To: INCITS T10 Committee
From: Matthew Bondurant, Quantum
Date: 14 July 2004
Document: T10/04-200r1
Subject: Modify ADT ACK and NAK to differentiate Initiate Recovery acknowledgements

B.11 Delayed response with recovery driven by timeout

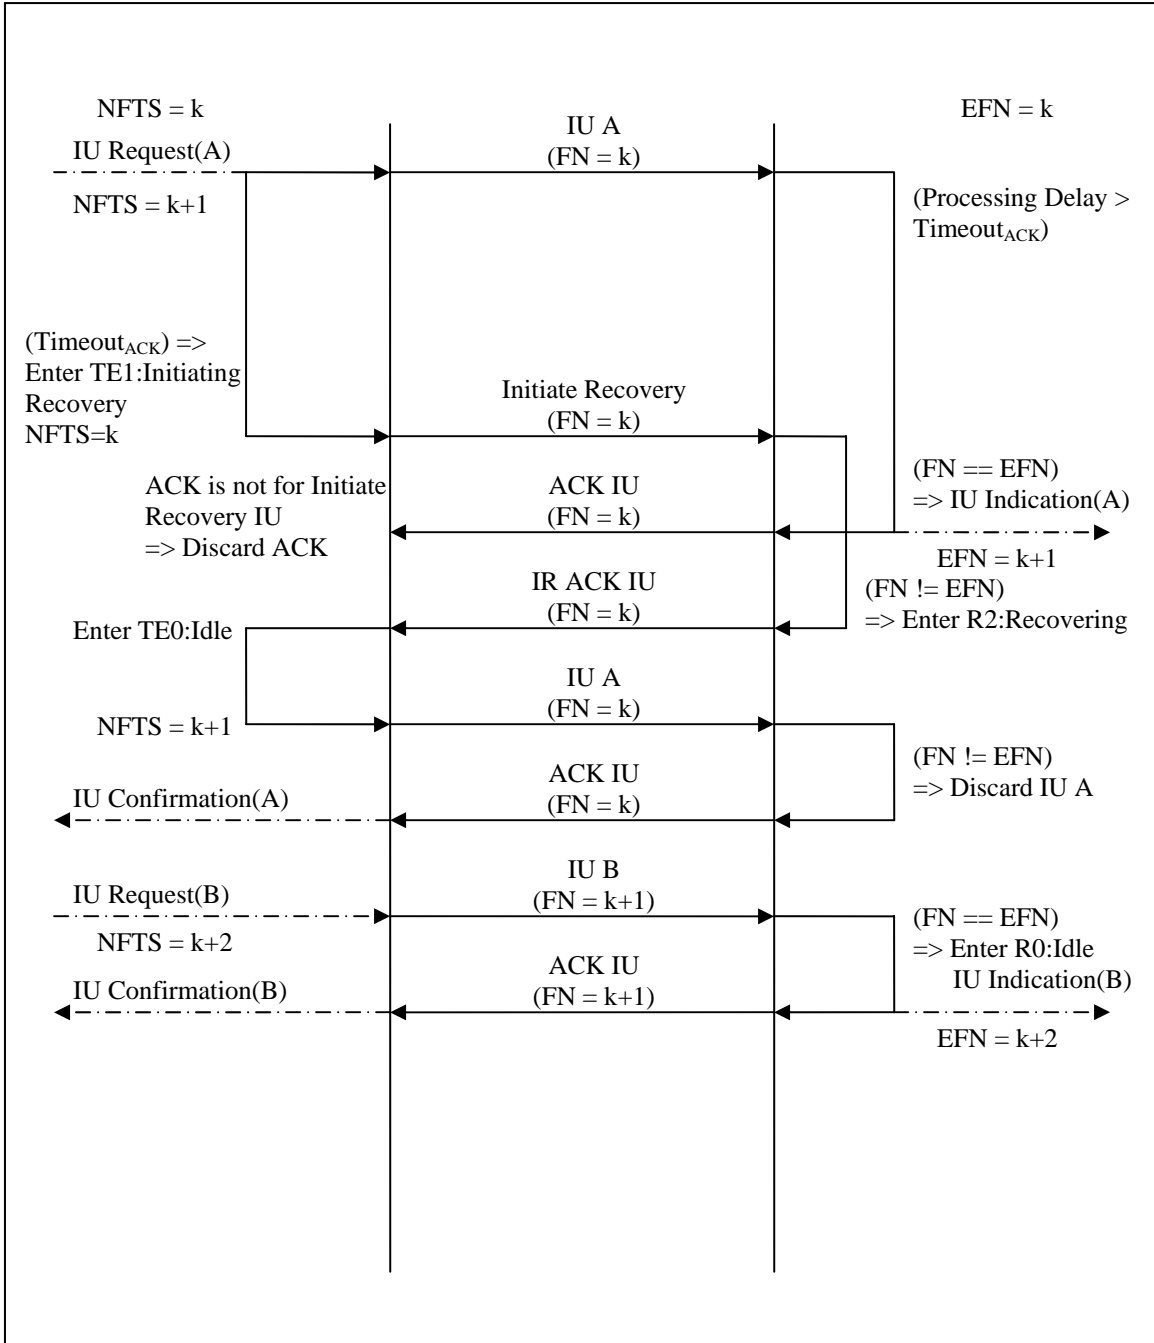
The following sequence shows how the error scenario posed in the statement above would be handled after implementing the solution discussed below. This scenario should be added to appendix B as follows:

Figure B.11 shows a scenario in which the recipient of a frame is delayed in processing the frame by some other factor in the device. It is the timeout on the ACK which begins the error recovery sequence.
